**EAST AREA COMMITTEE MEETING – 25<sup>TH</sup> APRIL 2013**

**Amendment De-brief Note**

ITEM: APPLICATION REF: **12/1613/FUL**

Location: Land to the r/o 289-293 Cherry Hinton Road

Drawing SITE LOCATION PLAN	
Scale 1:1000 & 1:200	Date AUGUST 2009
JOB No. 0616/100	REVISION A

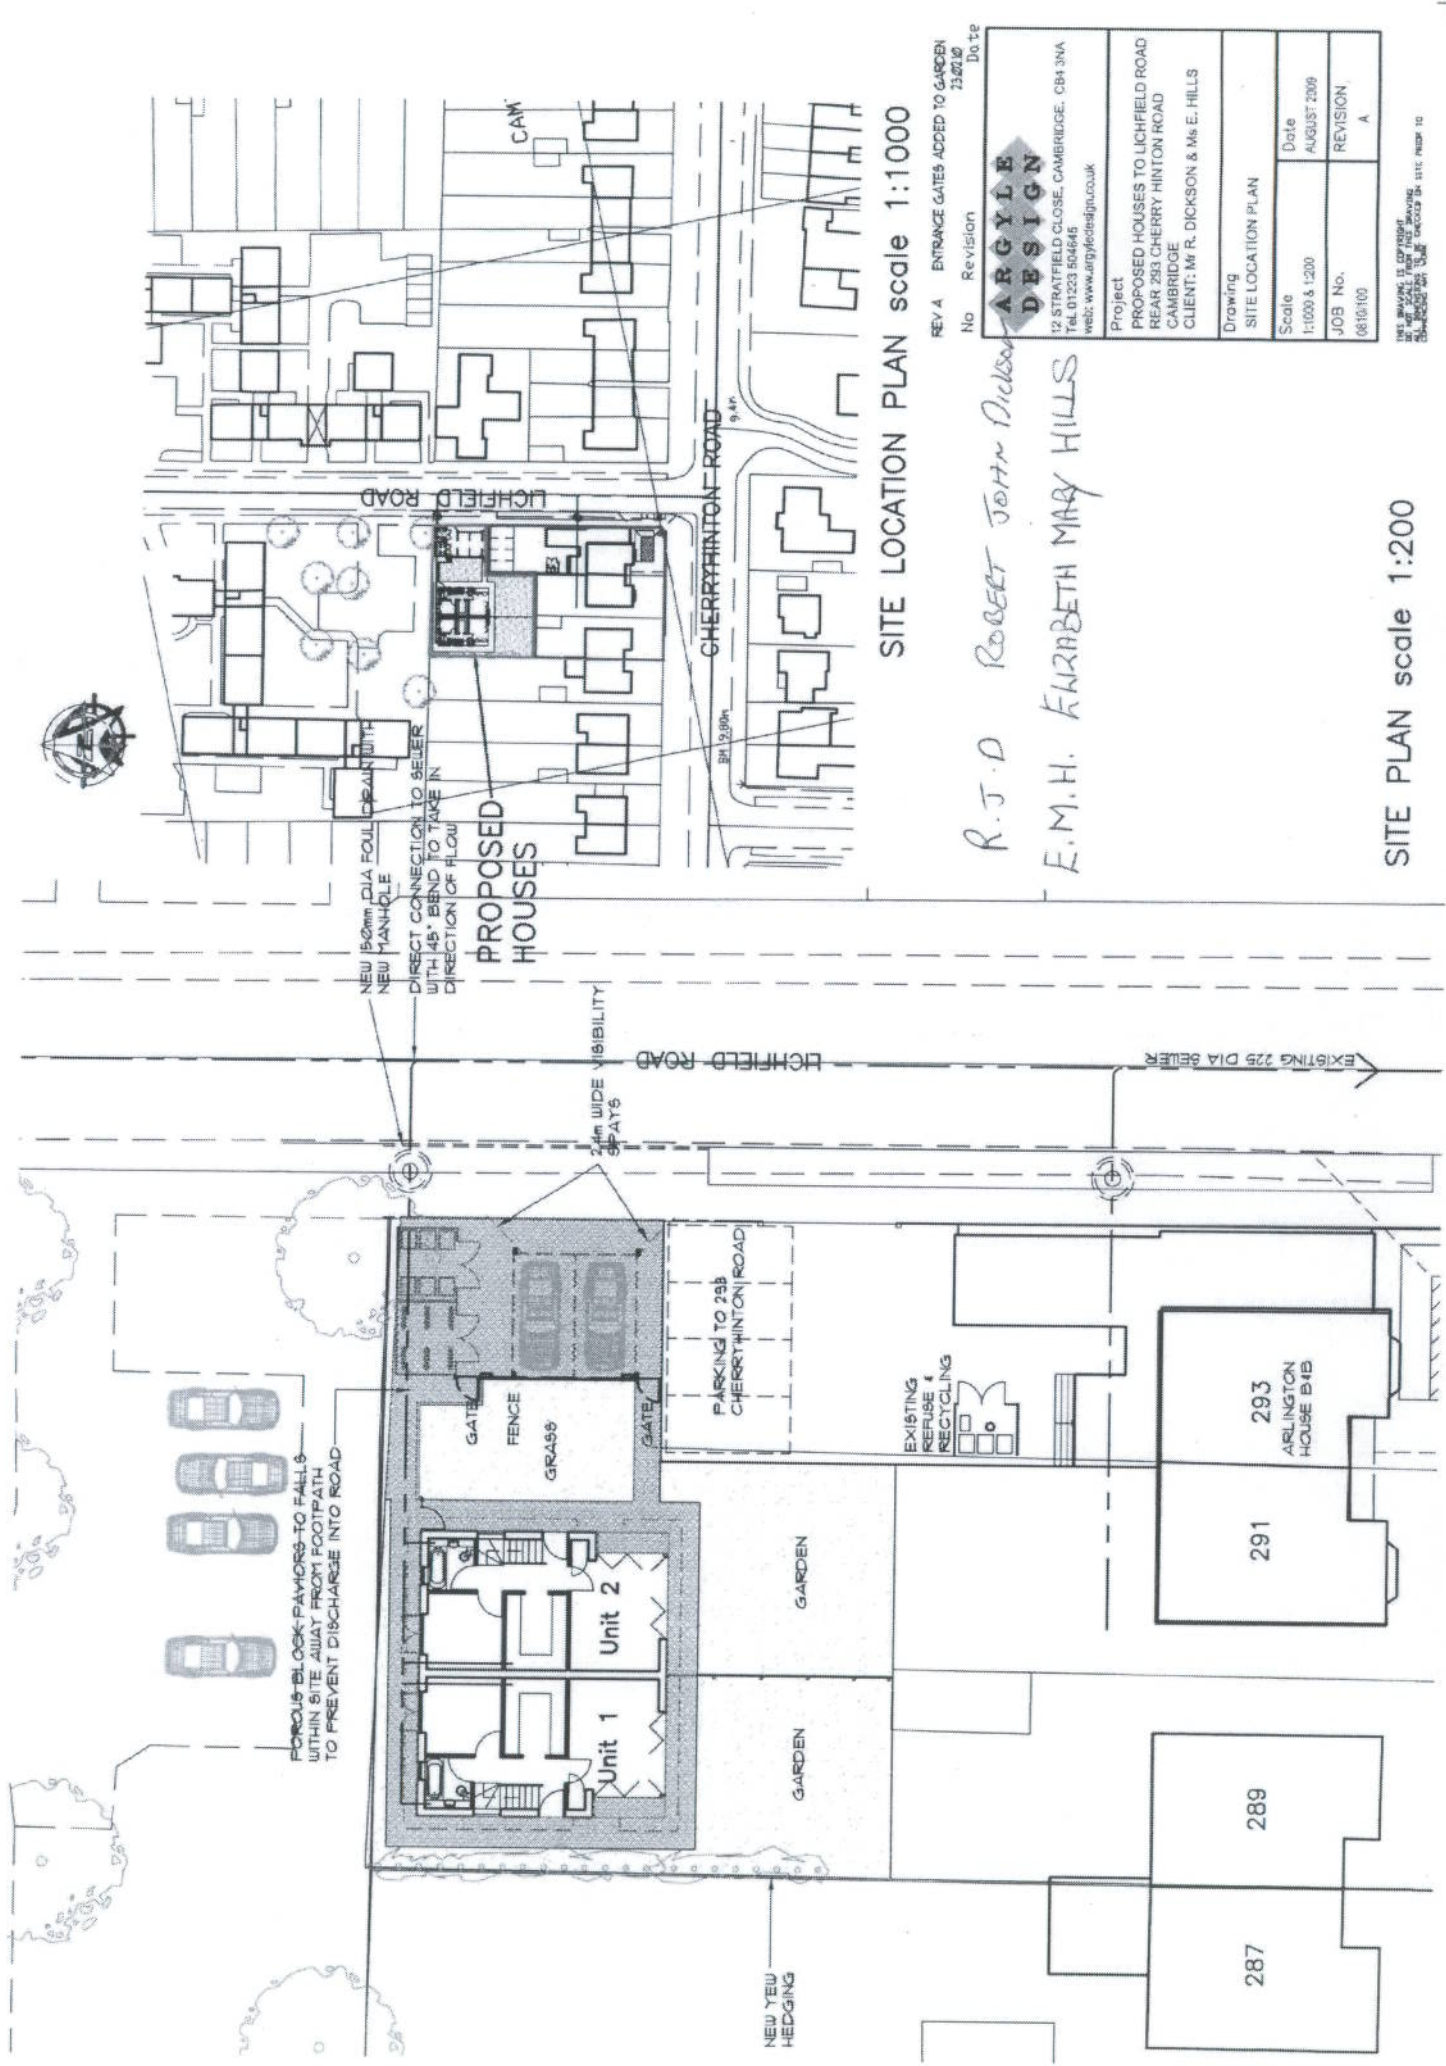
The houses referred to in the appeal decision (reference 10/0739/FUL) were set back further from the street than what is proposed in the current planning application. The appeal decision and site plan are attached to the amendment sheet. I therefore consider there to be no direct comparison between the current planning application and the previous planning application, in reference to its impact on the street scene.
